FEDERAL COMMUNICATIONS COMMISSION

In re: W201CN, Afton, VA
BPFT-20100304AAA
Facility ID # 93681

This refers to: (1) the above-captioned application for W201CN, Afton, Virginia.

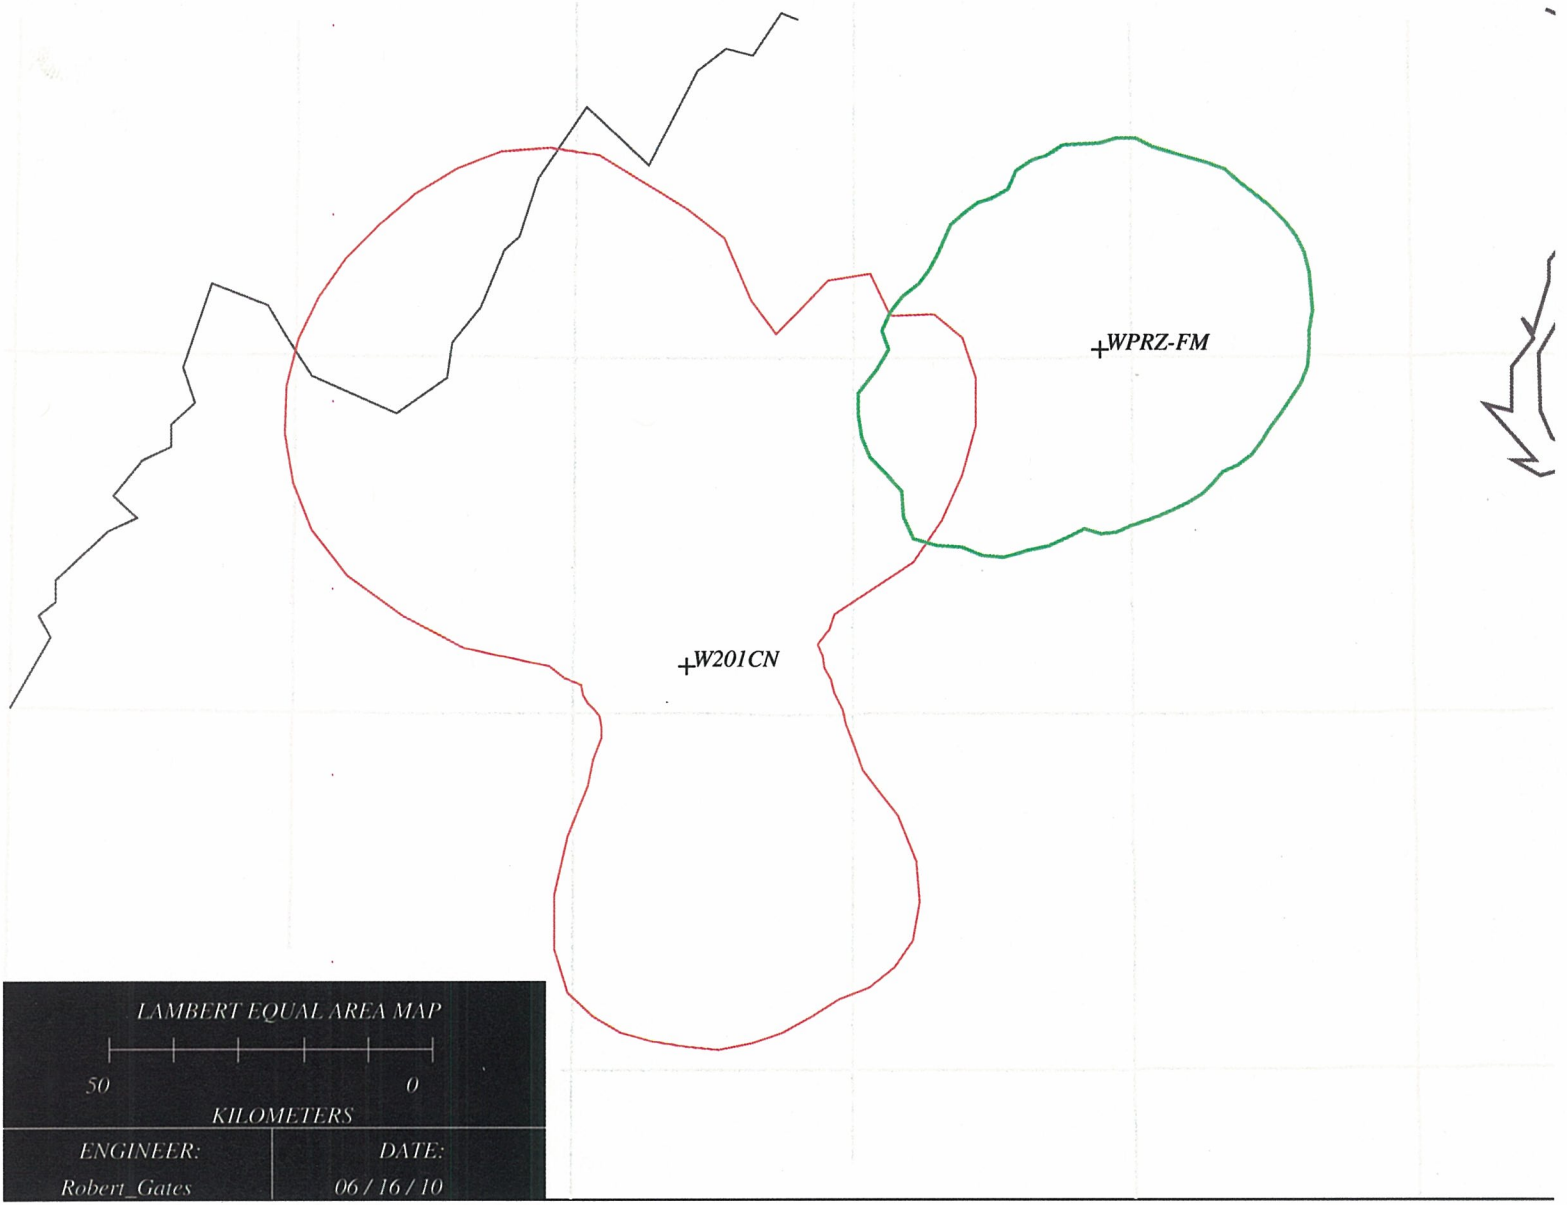
An engineering study has revealed the application violates 47 C.F.R. § 74.1204(a) with respect to WPRZ-FM, Brandy Station, VA (BMPED-20100301ABZ). Section 74.1204(a) states that an application for a FM translator station will not be accepted if the proposed operation would involve prohibited overlap of predicted field strength contours with any other authorized station. The proposed 37 dBu interference contour overlaps with the 57 dBu protected contour of WPRZ-FM.

In light of the above, the application BPFT-20100304AAA filed by Stucomm, Inc. is unacceptable for filing pursuant to 47 C.F.R. § 73.3566(a) and IS HEREBY DISMISSED. This action is taken pursuant to 47 C.F.R. § 0.283.
